Steven D. Capps  
Vice President  
McGuire Nuclear Station

Duke Energy Carolinas, LLC  
McGuire Nuclear Station, Units 1 and 2  
Docket Nos. 50-369 and 50-370  
Renewed Facility Operating Licenses NPF-9 and NPF-17

SUBJECT: License Amendment Request to Revise Technical Specification 3.3.1, "Reactor Trip System (RTS) Instrumentation"

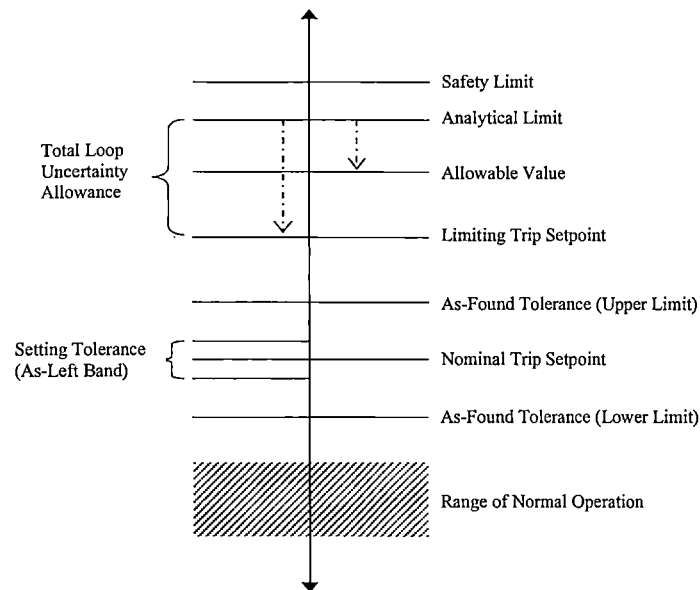
Evaluation of setpoint acceptability requires comparison of the total loop uncertainty against the operational ranges and the protected limits (process, analytical, and/or safety limits). This setpoint relationship is based on guidance in Regulatory Guide (RG) 1.105, Revision 3, "Setpoints for Safety-Related Instrumentation." The typical reactor protection and/or safeguard setpoint relationship, depicting a high process setpoint, is depicted as follows:
